REQUEST FOR INFORMATION DATE: September 28, 2016 NO.: RFI-305

Project Name: 15051-Webster University Interdisciplinary Science Building Project No.: 15051

Subject: Preaction panel room dimensions

REVISED PREACTION SYSTEM ROOM SIZE

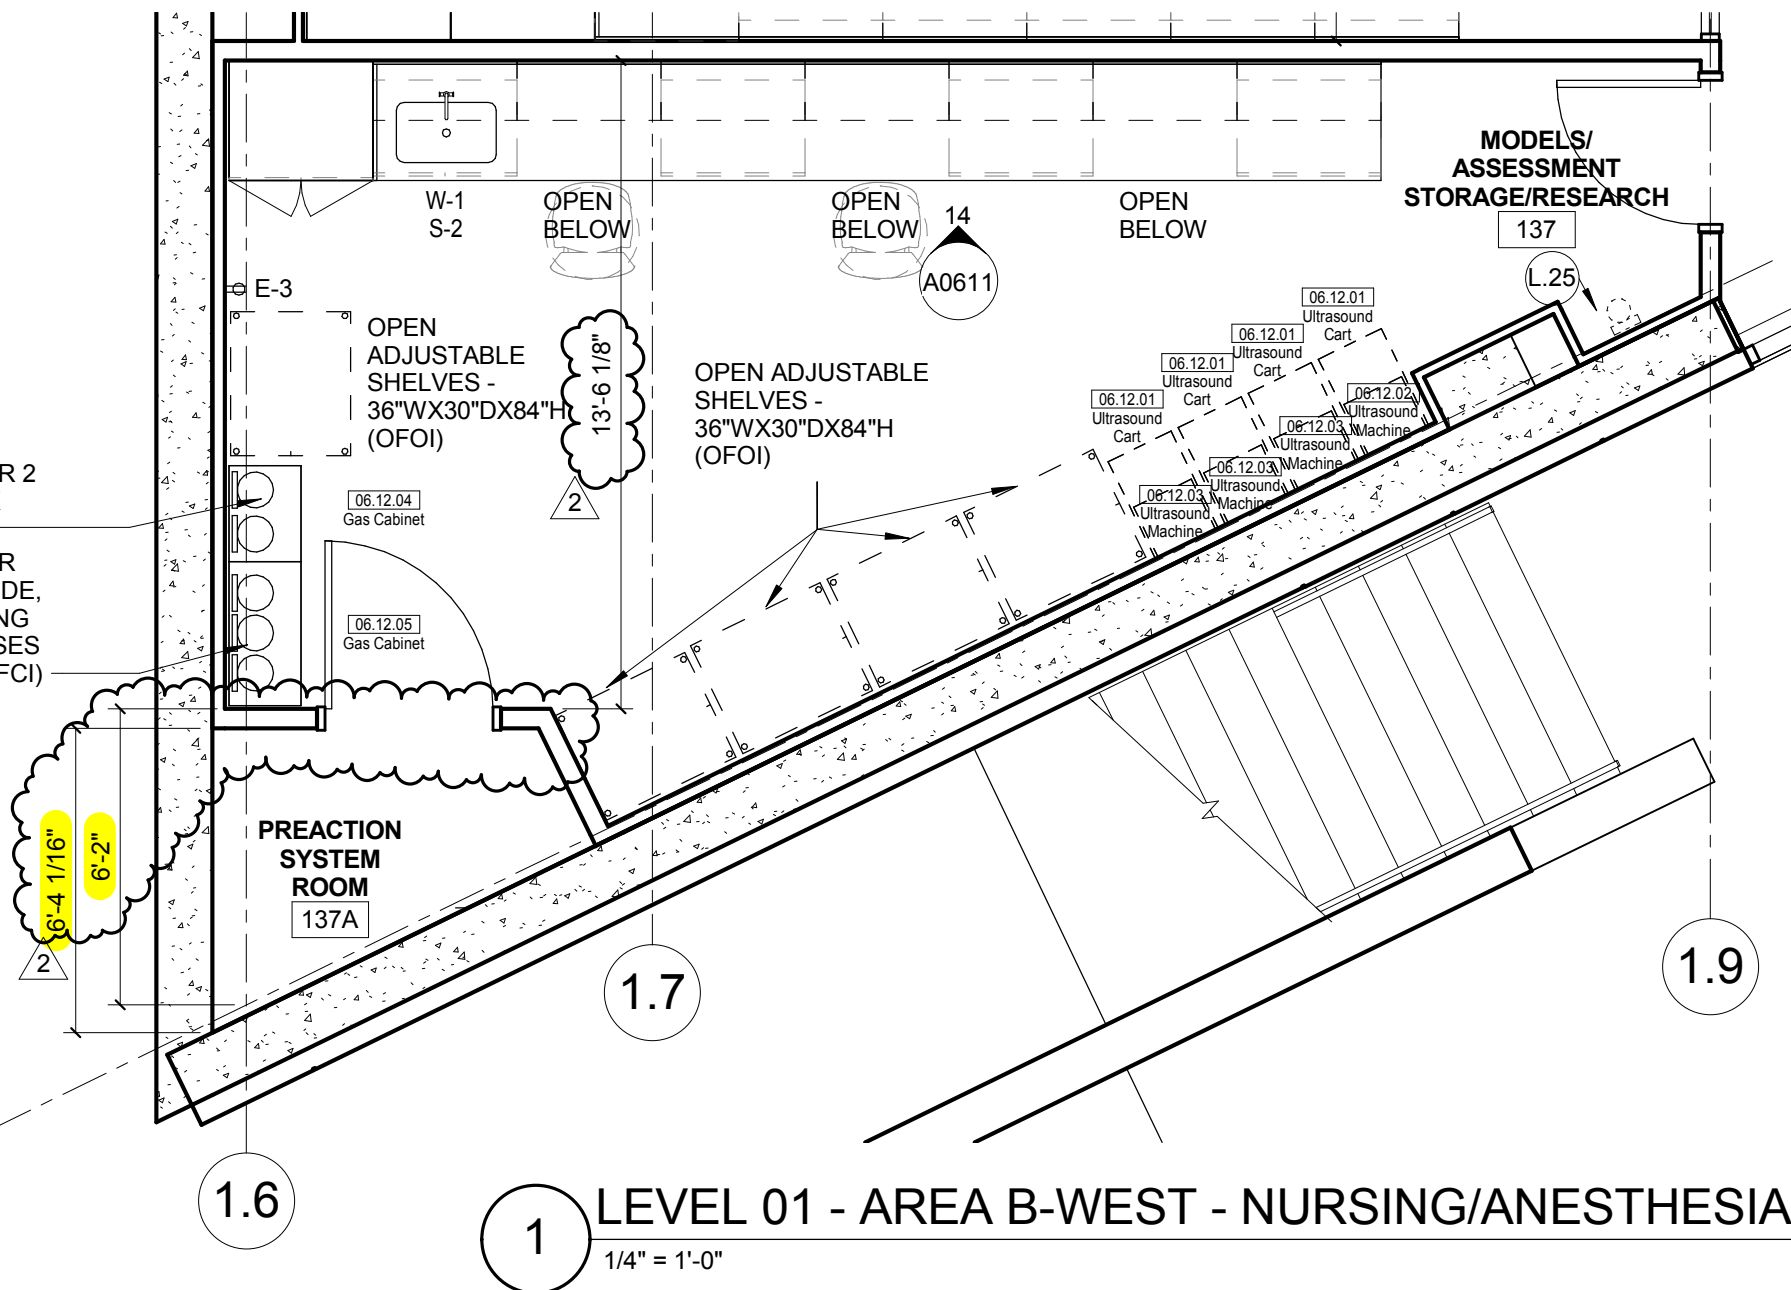
Currently the small room south of the Models/Assessment Storage/Research 137 used to hold the preaction cabinet is only 4'-11" deep (north to south) from the corner of the concrete walls. The cut sheets for the FireFlex cabinet gives a cabinet and dimensional clearances of 6'-3 1/2" from corner to edge of clearance. The fire protection contractor requests 3" additional for some variance for a total of 6'-6" from the corner to inside face of the north wall. Please see the attached image for reference.

Suggestion: Please advise on whether or not the room layout should be adjusted.

Revise Preaction system room size per attached sketch to accommodate the preaction cabinet.
